HISTORIC AND DESIGN REVIEW COMMISSION

HDRC CASE NO: 2016-355
ADDRESS: 615 SOLEDAD ST
LEGAL DESCRIPTION: NCB 141 (MAIN & GIRAUD), BLOCK LOT 19
ZONING: D RIO-3
CITY COUNCIL DIST.: 1
APPLICANT: Beverly Schantz/LK Design Group, Inc
OWNER: Demetrios Macris/Soledad Realty, LTD
TYPE OF WORK: Exterior modifications, landscaping
REQUEST:

The applicant is requesting conceptual approval to perform exterior modifications to the non-historic structure at 615 Soledad. The applicant has proposed the following:

PVA - SOUTH ELEVATION

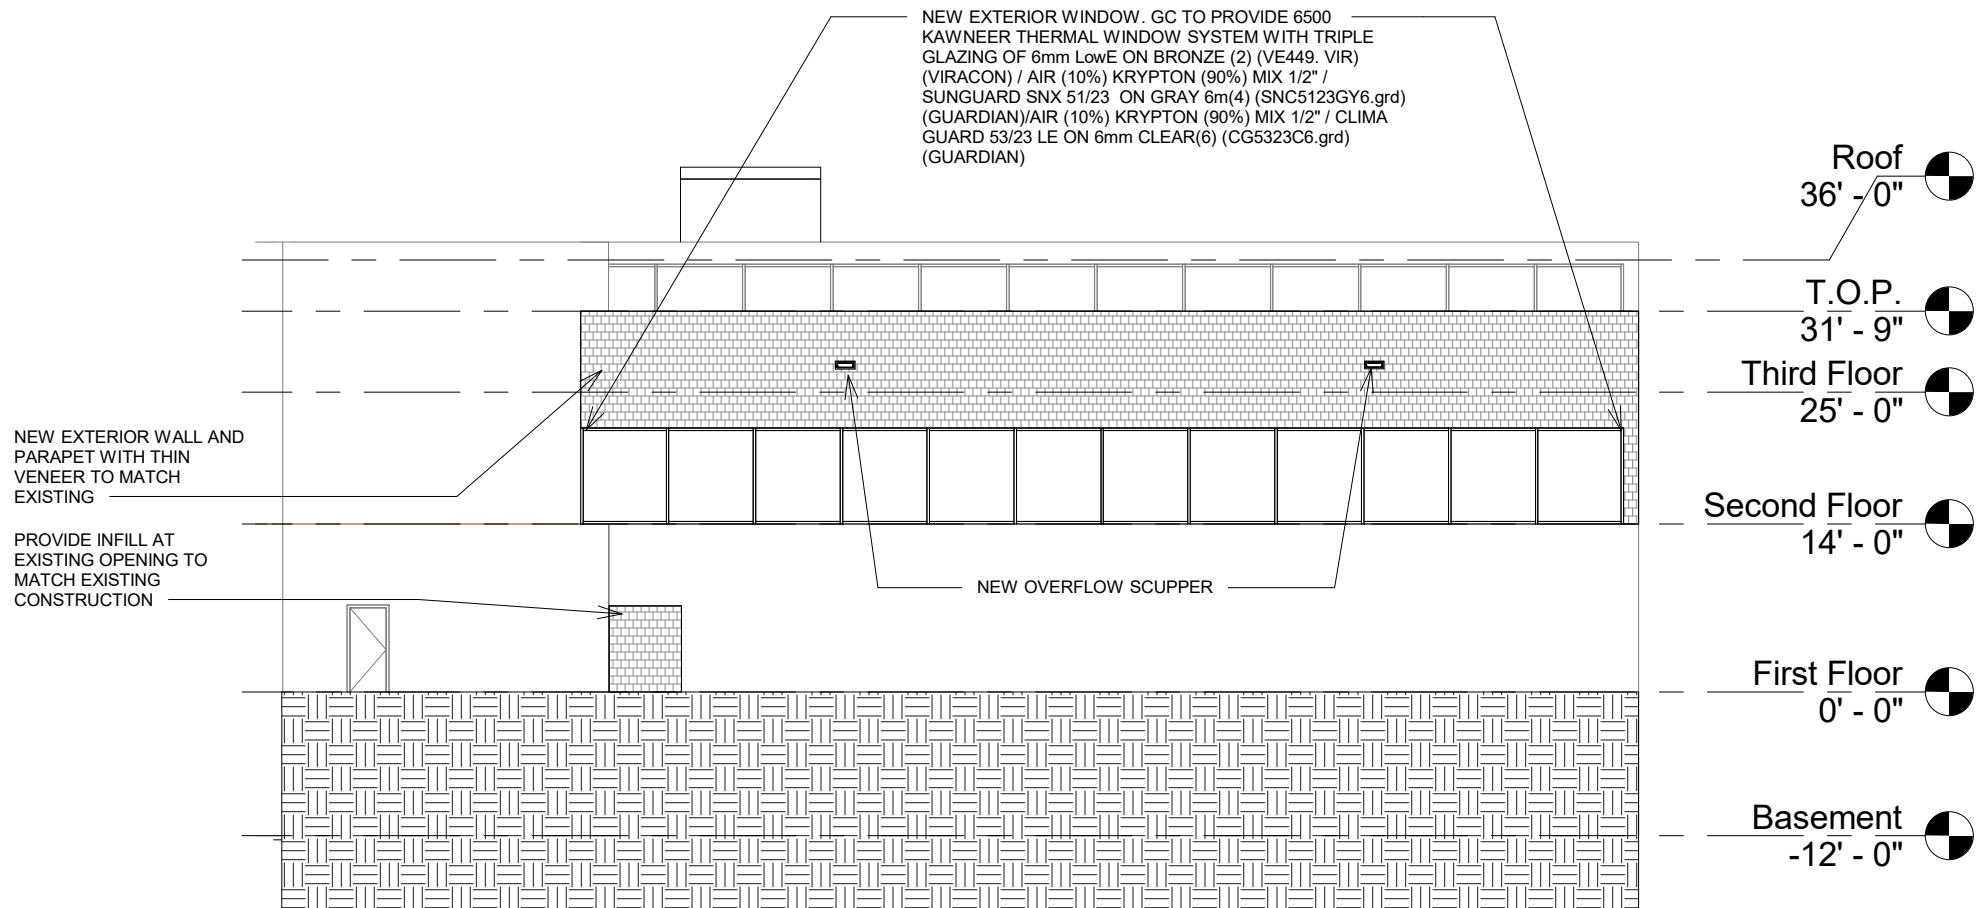
- d. Along the south façade, the applicant has proposed to enclose the previous open air patio on the second level. The applicant has proposed for the addition to feature massing that is subordinate to that of the original structure. The applicant has proposed materials that include a stone veneer to match the existing veneer as well as a new exterior glazing system. The applicant's proposed addition and materials are consistent with the UDC Section 35-674.

- e. The existing Giraud Street (south) façade features a set of double doors. The current opening features steel security doors. The applicant has proposed to enclose this existing opening. Staff finds the enclosing of this opening appropriate. Staff finds that the removal of this door will not negatively impact the architecture of the structure.

- i. That the applicant provide a detail of the addition's proposed window installation prior to returning for final approval.
- ii. That the applicant provide a detail of the proposed addition's veneer prior to returning for final approval.
- iii. ARCHAEOLOGY-Archaeological investigations are required for all excavations in the basement of the property. The archaeological scope of work should be submitted to the OHP archaeologists for review and approval prior to the commencement of field efforts. The development project shall comply with all federal, state, and local laws, rules, and regulations regarding archaeology.
